March 21, 2023

ADDENDUM NO. 4

Board of County Commissioners ITB 2023-003 Dunkirk District Park Tennis Court Complex Construction

62SM-R6 SURFACE MOUNT BENCH

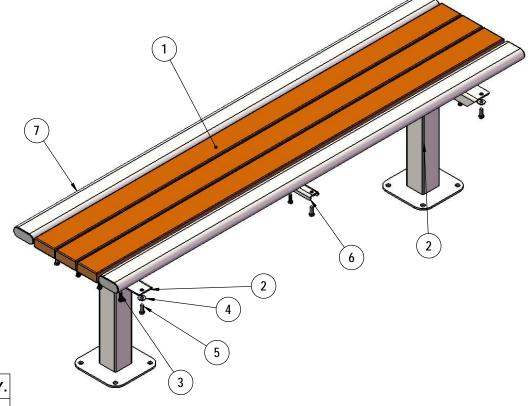
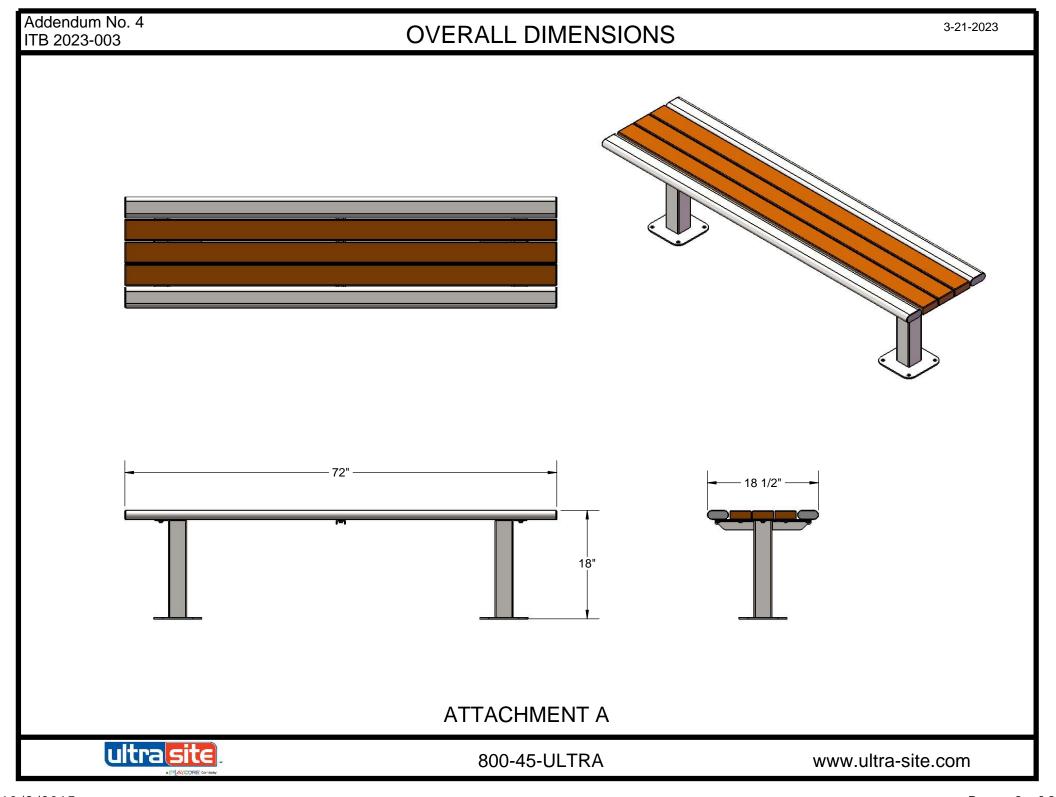
Contract Drawings, Sheet C204, Double-Sided Court Bench, Addition

Ultrasite Model # 62SM-R6 specifications, included as Attachment A of this addendum.

Type 847D/848D Longitudinal stainless steel grate (ADA)

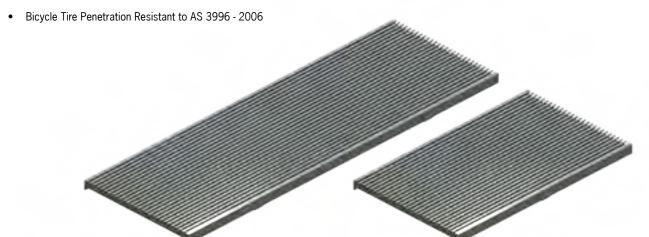
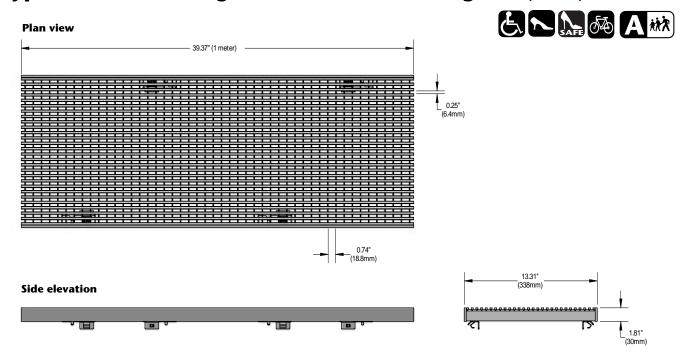
Contract Drawings, Sheet C303, Addition

- Trench Drain TD200-K300-12" Internal Width-Pedestrian Traffic-Load Class A-Grate Type 848D Stainless.
- Trench Drain TD300 K300-12" Internal Width-Pedestrian Traffic-Load Class A-Grate Type 848D Stainless.
- Trench Drain TD400 K300-12" Internal Width-Commercial Traffic-Load Class C-Grate Type 876D Iron.
- ACO Specification Information for Type 847D/848D Longitudinal stainless steel grate (ADA), included as Attachment D of this Addendum.
- ACO Specification Information for Type Type 876D Longitudinal ductile iron grate (ADA), included as Attachment E of this Addendum.

ATTACHMENT G

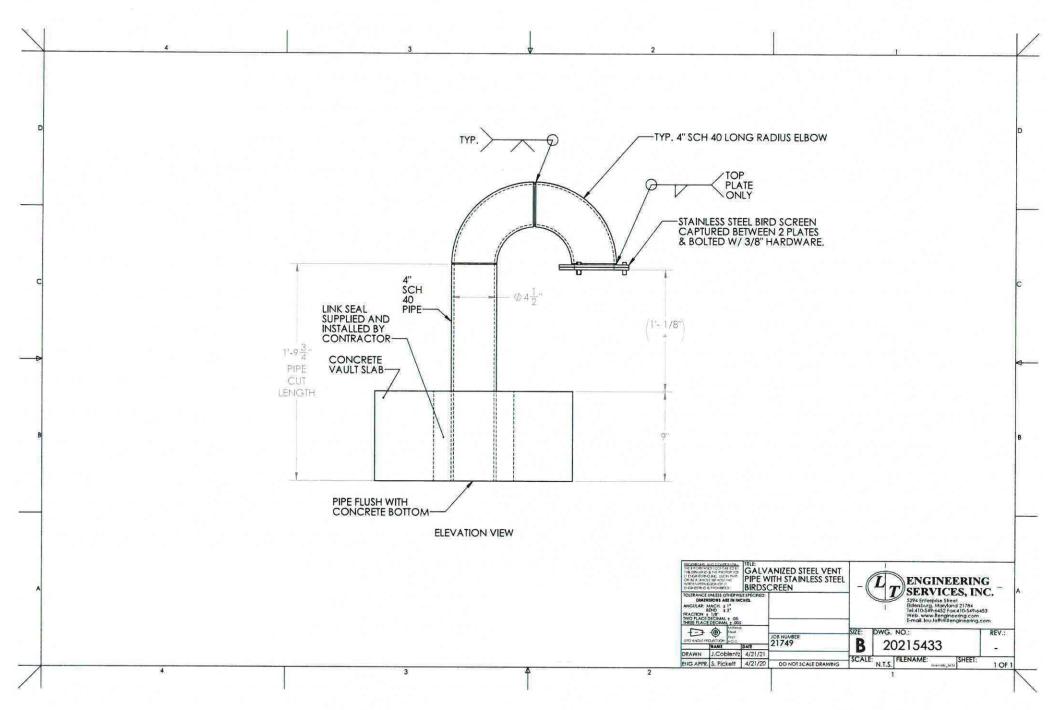
Contract Drawings, Sheet C403, Addition

- The PS-1 Pump chamber shall have a 4" Sch 40 PVC pipe goose neck added.
- Vent Pipe Specifications, included as Attachment G of this Addendum.

(3) DETAIL - EQUIPMENT MOUNTING PEDESTAL

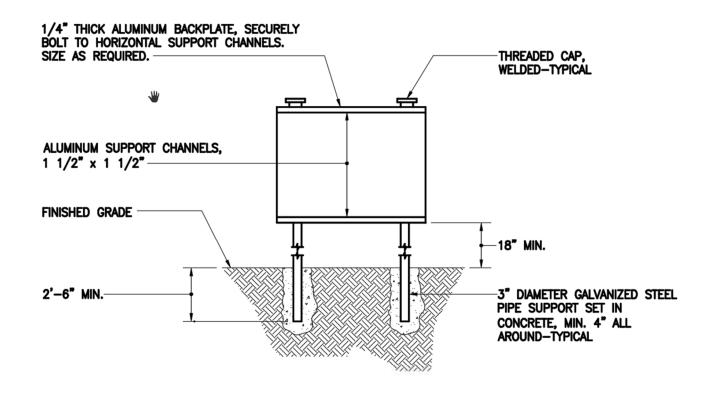
Contract Drawings, Sheet E5.1, Addition

- Pole Mount detail, included as Attachment H of this Addendum.
- Preliminary Foundation and Pole Assembly, included as Attachment I of this Addendum.
- Panel schedule for the Mini Powerzone, included as Attachment I of this Addendum.
